**Field Service
TECH TIP
NEWS****RI-0010**

IM-5006

HIGH REMOTE SPEAKER VOLUME

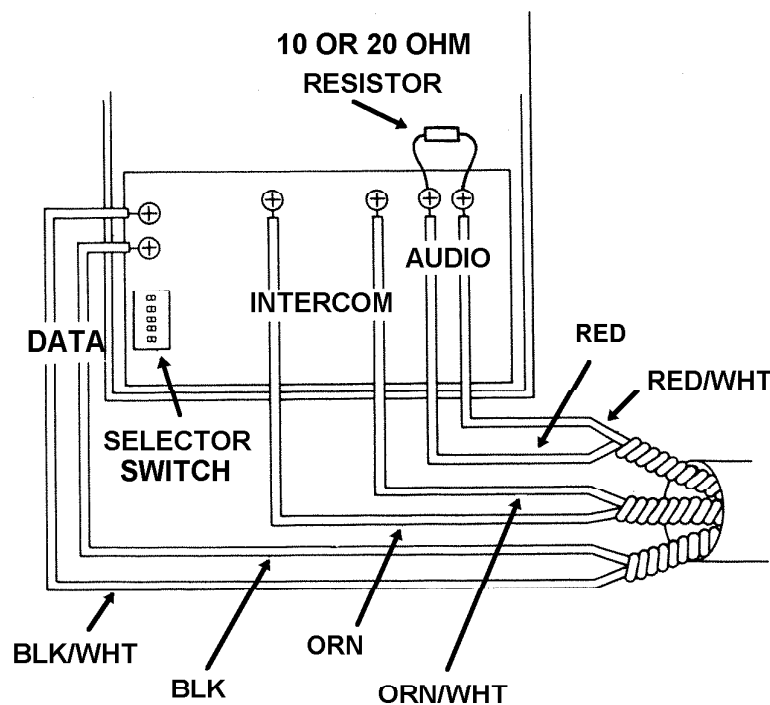
PURPOSE: In some instances, where only 4 - 8 remote speakers are used with a system (as opposed to being fully loaded) the radio volume at the remote speaker locations may be too loud; even at the lowest setting.

SOLUTION: Since the IM-5006 uses the "system resistance" as part of the volume control, it may be necessary to add a 10 ohm, 1/4 watt or 20 ohm, 1/4 watt resistor across the red and red/white pair.

For convenience sake, it is recommended that the resistor be placed at a remote station, rather than at the master.
